Amendments to the Drawings:

REMARKS

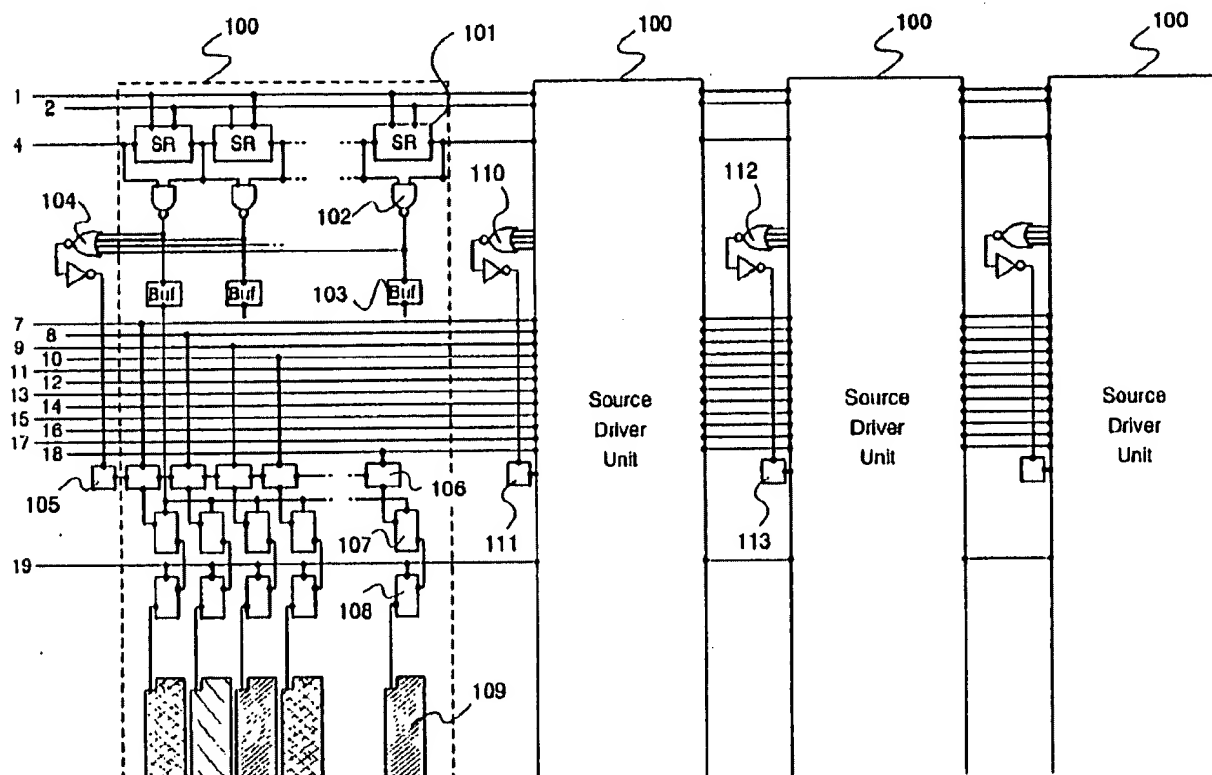
Paragraph 4 of the Official Action objects to the drawings asserting that "the current source provided in the source signal line driving circuit for supplying a current to the level shifter" is not shown in the drawings (page 3, Id.; emphasis in original). The Applicants respectfully disagree and traverse the above assertion in the Official Action.

circuit for supplying a current to said level shifter based on the pulse from the shift register" (see, e.g., Figure 1, reproduced below).

The Applicants respectfully submit that Figure 1, in fact, shows a whole driving circuit including a current source provided in a source signal line driver circuit, which is supported in the specification, for example, at page 16, line 14+. Reconsideration and withdrawal of the objections are requested.

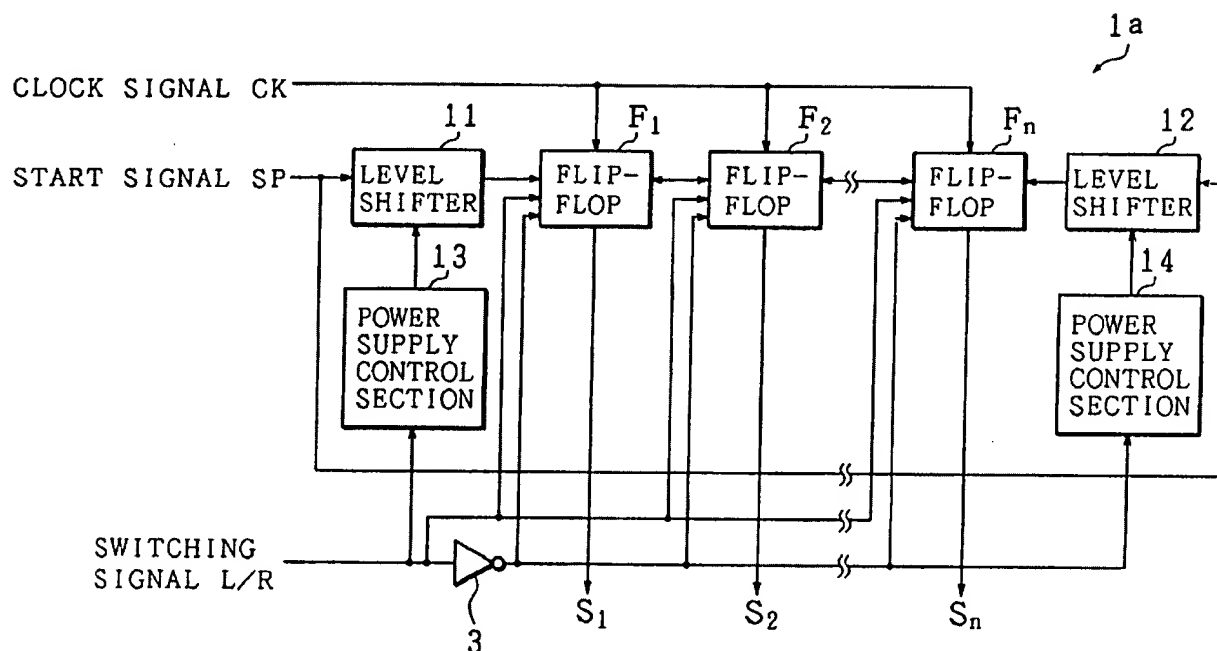
The Official Action relies on power supply control section 13 to allegedly teach the current source of the present claims, on electric power shifters 11 and 12 to allegedly teach the level shifter of the present claims, and on shift register 53a to allegedly teach the shift register of the present claims (page 5, Paper No. 20051011). It is noted that the shift register 53a (Figure 2) appears to include the flip-flops $F_1 \dots F_n$, the power supply control section 13, and the electric power shifters 11 and 12 shown in Figure 4. In any event, even if one were to assume that the power supply control section 13 is the current source of the present claims, Satoh does not teach or suggest that the power supply control section 13 supplies a current to the electric power shifters 11 and 12 (allegedly the level shifter) based on the shift register (allegedly shift register

53a and/or flip-flops $F_1...F_n$) (see Satoh at column 7, lines 12-14 and Figure 4, reproduced below).

Marshall does not cure the deficiencies in Satoh. Marshall is relied upon to allegedly teach "that the current source supplies the current only when the shift register serially outputs the pulses" (page 5, Paper No. 20051011). However, Satoh and Marshall, either alone or in combination, do not teach or suggest that the power supply control section 13 of Satoh could or should supply a current to the electric power shifters 11 and 12 (allegedly the level shifter) based on the shift register (allegedly shift register 53a and/or flip-flops $F_1...F_n$).
